Technical Service Information

THM 440-T4 SLIPPING OR NO 1-2 SHIFT (VESPEL RINGS)

Figure 1

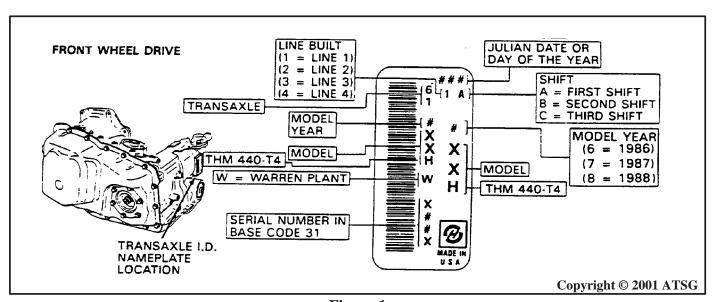
A soft, slipping or no 1-2 shift condition may result if the two cast iron seals between the driven sprocket support and 2nd clutch housing bind to the driven sprocket support and wear into the 2nd clutch housing.

DATE OF PRODUCTION CHANGE: (Figure 1)

Start of production for all 1987 THM 440-T4 transaxle models.

Figure 2 Figure 3

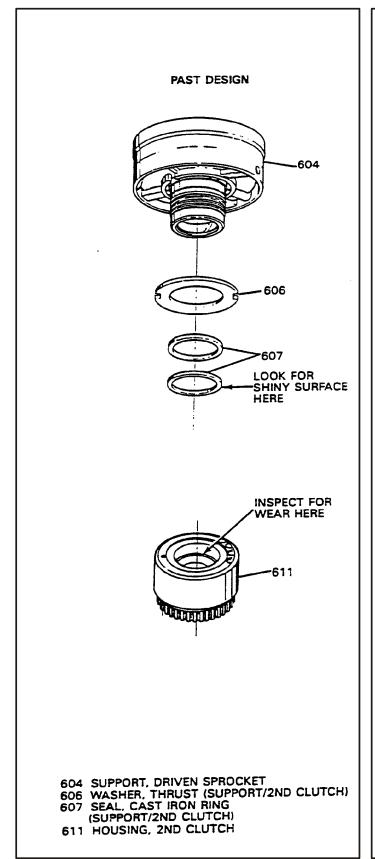
SERVICE ACTION: (Figure 2)

Inspect the cast iron oil seal rings (607) for wear (indicated by a shiny surface on the O.D.) and the 2nd clutch housing (611) for wear (grooves caused by the seal rings). The driven sprocket support may not appear affected, but must be replaced if these wear conditions are present.

For all 1984 through 1986 model year THM 440-T4 transaxles, it is recommended that the new Vespel (TM) oil seal rings, 4-lobe ring seals and driven sprocket support be installed with other parts that indicate wear (such as the 2nd clutch housing).

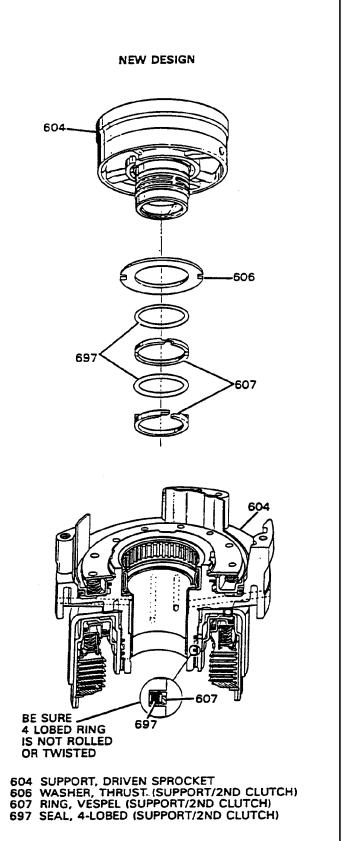
Due to changes in the driven sprocket support for 1987, the new Vespel (TM) oil seal rings and 4-lobe ring seals are not interchangeable with the cast iron oil seal rings on models built prior to 1987 Start Of Production (SOP). Changes made to the driven sprocket support include deeper seal ring grooves and 'cutouts" to accommodate the ring tangs which prevent the Vespel (TM) oil seal rings from rotating (refer to Figure 3).

SERVICE NOTES; (Figure 3, Item 697)

IMPORTANT: When installing a 4-lobe ring seal, make sure that it is not rolled or twisted. Lubricate the vespel rings with transaxle fluid or petroleum jelly for easier installation into the 2nd clutch housing.
